**Addendum to Report on
Geological & Hydrogeological issues for concern
Arising from Planning Application 2015/2089/P
11 Rosslyn Hill London NW3 5UL**

1A. This report is an addendum to that written by me on 2nd November 2015 and commissioned by Mr Paul Woolf of Air Studios Lyndhurst Road; it arises because of discoveries made in December 2015 within the archives of the engineering firm of Beers who were involved with converting the original chapel into Air Studios.

Fig 3A

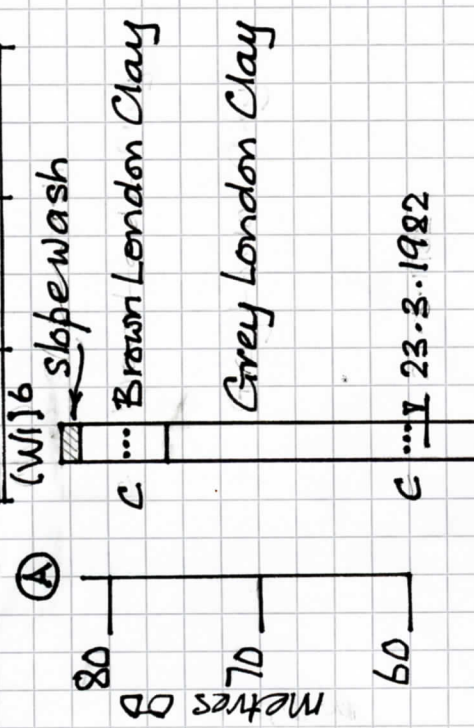
17A. The Wimpey boreholes describe suites of concretionary nodules and these are shown on the vertical cross sections (Figs. 2Ab, 3A & 4A); only one such feature was recorded by the Ground Exploration holes (BH2) but its level agrees with one from the Wimpey holes. So it is reasonable to expect these to be present across the site. They will present an obstacle to piling.

18A. The Wimpey laboratory tests provide a useful profile of strength with depth to compare with that from laboratory tests undertaken by Ground Exploration and the profiles of both are shown on the Sections J-H and I-J (Figs. 3A & 4A). Both investigations predict strengths ranging from 250kN/m² to 260kN/m² at the level of the Northern Line tunnels reducing to 60kN/m² to 70kN/m² near base of the weathered London Clay. Further there is clearly a

FIG 2B

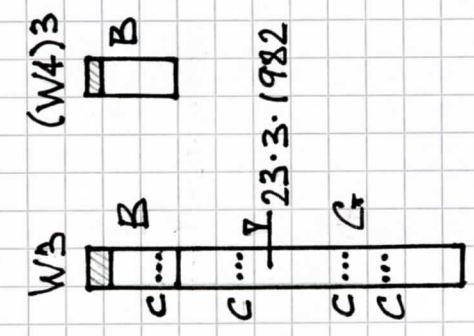
10A. Water level data from Ground Engineering is suspect by virtue of the instrumentation used to gather it as explained in paragraphs 24 to 27 in First Steps' report of 2nd November 2015. Shepherd's Well, an established source of ground water issuing at ground level, was at the western end of Lyndhurst Road and in its day this water flowed down slope. Sections have thus been drawn normal to the topographic contours of the site to illustrate as far as possible any data that is likely to be relevant (Fig. 2A & B). Unfortunately the combined data fails to add any further information.

FIG 1A

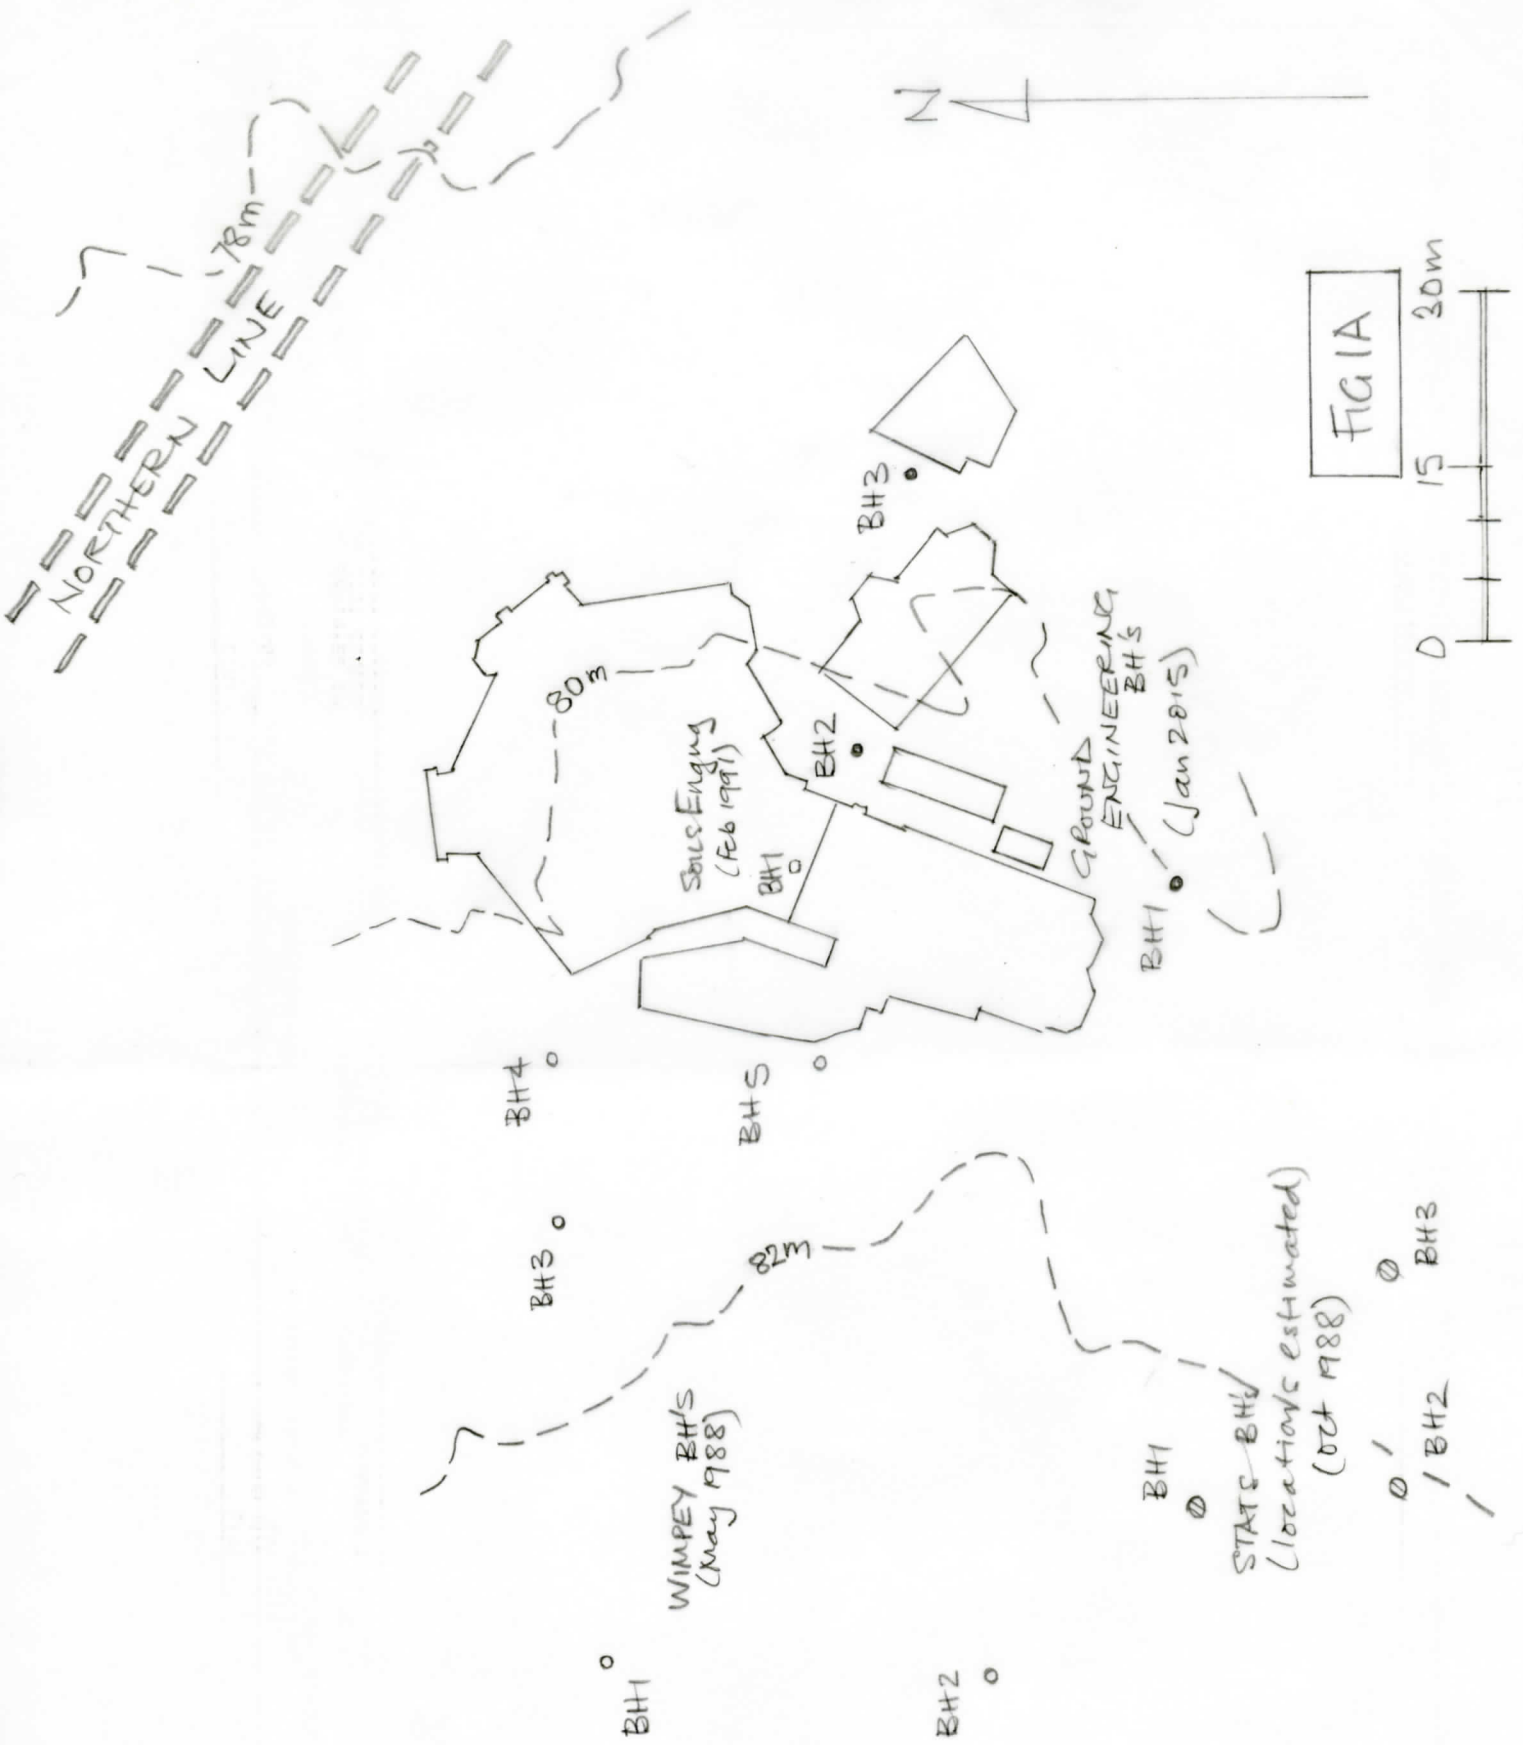
2A. Two ground investigations were found for the development of the Olive Centre, which was immediately adjacent to and upslope of Air Studios; one by Wimpey Laboratories (May 1982) for Phase 1 of the development (new apartments for the World Association of Girl Guides and Girl Scouts) and another for Phase 2 of the development (offices and the like) by STATS (October 1988). These complement the investigations of Ground Engineering (March 2015) for 11 Rosslyn Hill, immediately adjacent to and down slope of Air Studios. In addition a borehole drilled by Soils Engineering (February 1991) at Air Studios, as part of the studies for controlling groundwater there during conversion of the chapel, was also found. The location of all known boreholes is now shown on Fig 1A.
